UNITED STATES PATENT AND TRADEMARK OFFICE

Office Action Summary	Application No.	Applicant(s)	
	10/776,565	HAWES, RAYMOND W.	
	Examiner	Art Unit	
	Branon C. Painter	3635

DETAILED ACTION

**FIG. 1**

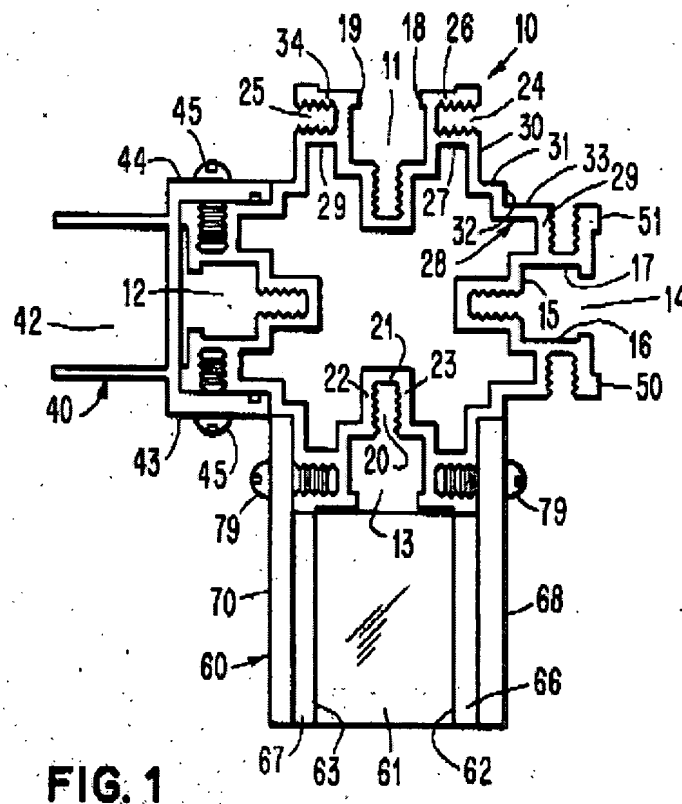
7. Claims 1-2 and 6-8 are rejected under 35 U.S.C. 102(b) as being anticipated by Corman (U.S. Patent No. 3,782,048).

8. Regarding claim 1, Corman discloses a structural element having all of the applicant's claimed structure, including:

A system including a plurality of types of modular structural components ("longitudinal elements" 40 and 60, Fig. 1) for construction of structures, each structural component including at least one of a plurality of structural elements, the structural elements comprising: chords, each chord including a generally elongated main body having generally square cross section ("support post" 10, Fig. 1) defined by four main walls surrounding a central bore and having four interior main surfaces (inner facing "bottom wall" 21, Fig. 1) and four exterior main surfaces ("side walls" 27 and 29, Fig. 1), and a T-slot structure extending along and centered on each exterior main surface, each T-slot structure having an interior T-slot adapted to accept a bolt type fastener, each T-slot including a shaft slot extending inwards from an outer surface of the T-slot structure and connecting with a cross slot extending at a right angle to the shaft slot at an inner end of shaft slot ("recesses" 11-14, Fig. 1).

10. Regarding claim 2, Corman discloses a straight chord that is generally vertically oriented and has a plurality of bolt holes for attachment ("longitudinal elements" 40 and 60, Fig. 1; "The element 40 is secured to the support post 10 by screws 45 extending through longitudinally spaced holes in the walls 43 and 44 of the larger U-shaped channel 41 of the element 40 and into the threaded grooves 24 and 25," column 4, lines 59-63).
11. Regarding claim 6, Corman discloses bolt holes near the ends of the structural element and spaced along the structural component ("The element 40 is secured to the support post 10 by screws 45 extending through longitudinally spaced holes in

12. Regarding claim 7, Corman discloses T-slot structures defined by two parallel slot side walls ("side walls" 16 and 17, Fig. 1) extending out in parallel from an exterior main surface ("side walls" 27 and 29, Fig. 1) and by two slot face walls extending inwardly from the slot side walls ("flanges" 18 and 19, Fig. 1).

*Fig. 4**Fig. 17*

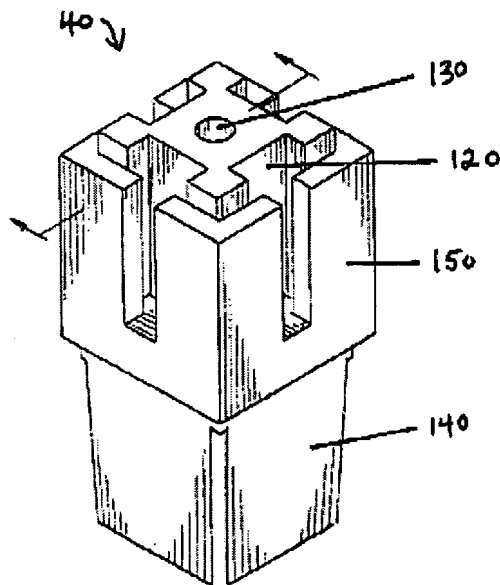
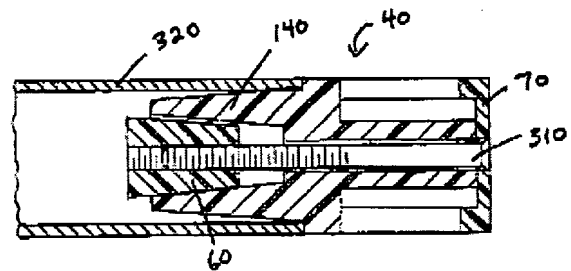
14. Claim 4 is rejected under 35 U.S.C. 102(e) as being anticipated by Altman (U.S. Patent No. 6,969,211).
15. Regarding claim 1, Altman discloses a frame structure connector system having all of the applicant's claimed structure, including:

A system including a plurality of types of modular structural components ("connector cap" 70, Fig. 17) for construction of structures, each structural component including at least one of a plurality of structural elements, the structural elements comprising: chords, each chord including a generally elongated main body having generally square cross section ("connector body" 40, Fig. 4) defined by four main walls surrounding a central bore and having four interior main surfaces (back walls of

"connector slots" 120, Fig. 4) and four exterior main surfaces ("side surfaces" 150, Fig. 4), and a T-slot structure extending along and centered on each exterior main surface, each T-slot structure having an interior T-slot adapted to accept a bolt type fastener, each T-slot including a shaft slot extending inwards from an outer surface of the T-slot structure and connecting with a cross slot extending at a right angle to the shaft slot at an inner end of shaft slot ("connector slots" 120, Fig. 4).

16. Regarding claim 4, Altman discloses a stub of square cross-section that slides into the chord and having at least one bolt hole ("wedge member" 60 with hole for "fastener" 310, Fig. 17).
